Information note

N° 10411AERRA

Errata sheet Rev 1.0 affecting products TLE9210x

TLE9210x errata

Figure 1 Falling edge of the internal LS control signal before the expiration of t_{FVDS}

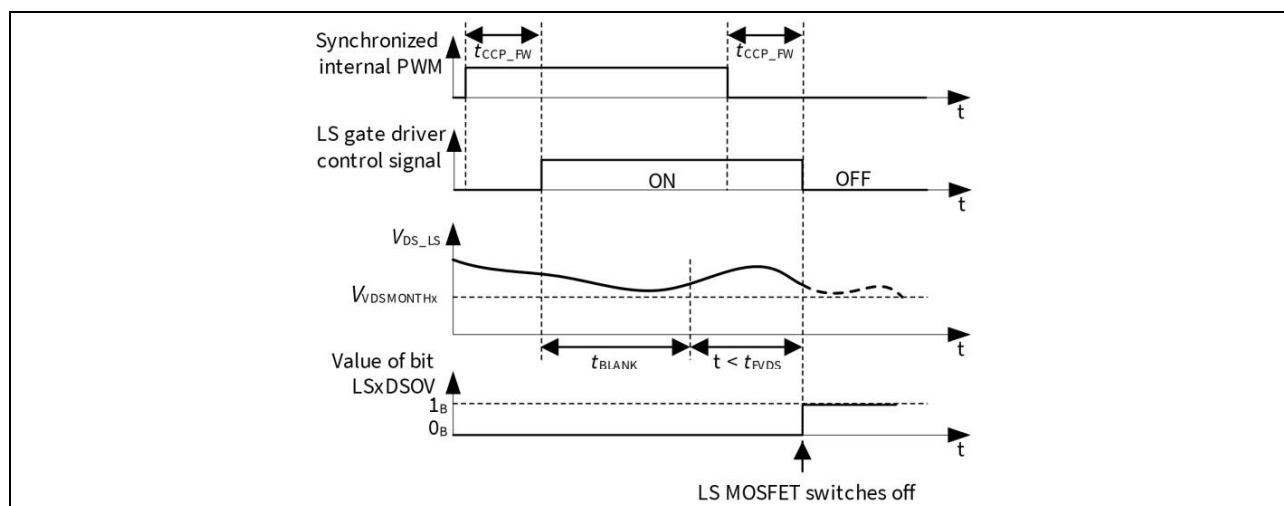
Actual behavior

After the expiration of t_{BLANK} , a VDSOV is detected for a LS if:

- a falling edge of the internal LS control signal is generated
- while $V_{\text{DS_LS}} > V_{\text{VDSMONTHX}}$ for $t < t_{\text{FVDS}}$ (**Figure 1**)

The LS is latched off and the VDSOV status bit of the corresponding LS is set.

Update the datasheets.

Figure 2 Falling edge of the internal HS control signal before the expiration of t_{FVDS}

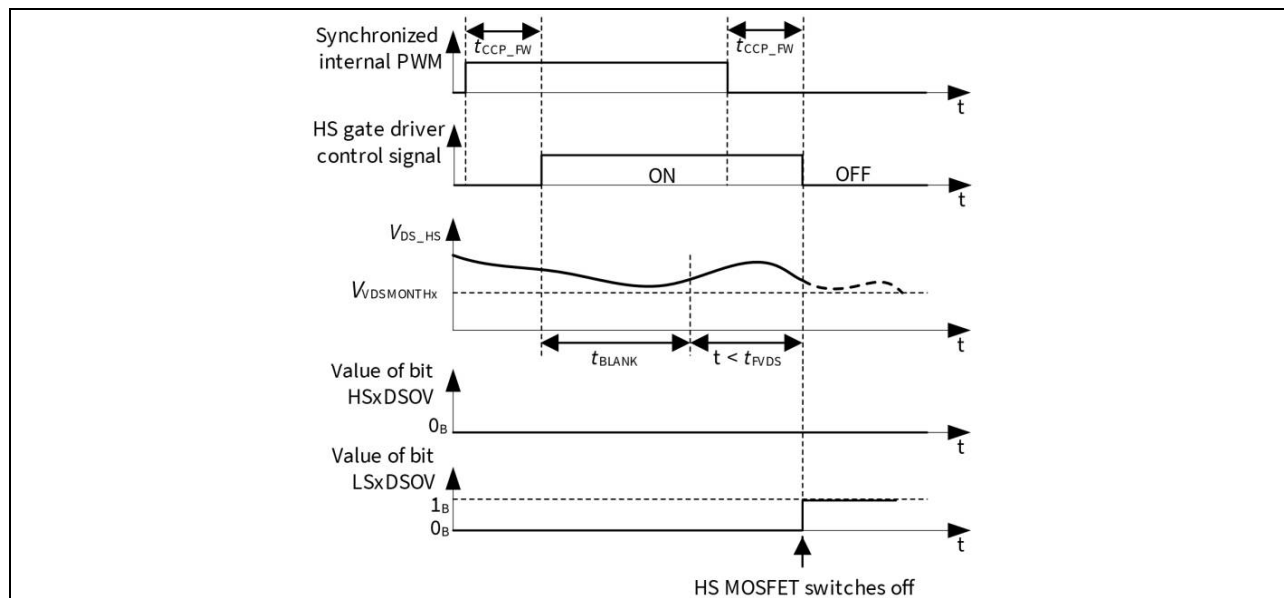
Actual behavior

After the expiration of t_{BLANK} , a VDSOV is detected if:

- a falling edge of the internal HS control signal is generated
- while $V_{\text{DS_HS}} > V_{\text{VDSMONTHX}}$ for $t < t_{\text{FVDS}}$ (Figure 2)

The device reaction is:

- the HS is latched off
- the VDSOV status bit of the HS is not set
- the VDSOV status bit of the LS from the same half-bridge is set

Whenever a VDSOV is reported, perform an off-state diagnostic to confirm which MOSFET of the half-bridge is impacted.

Update the datasheets.
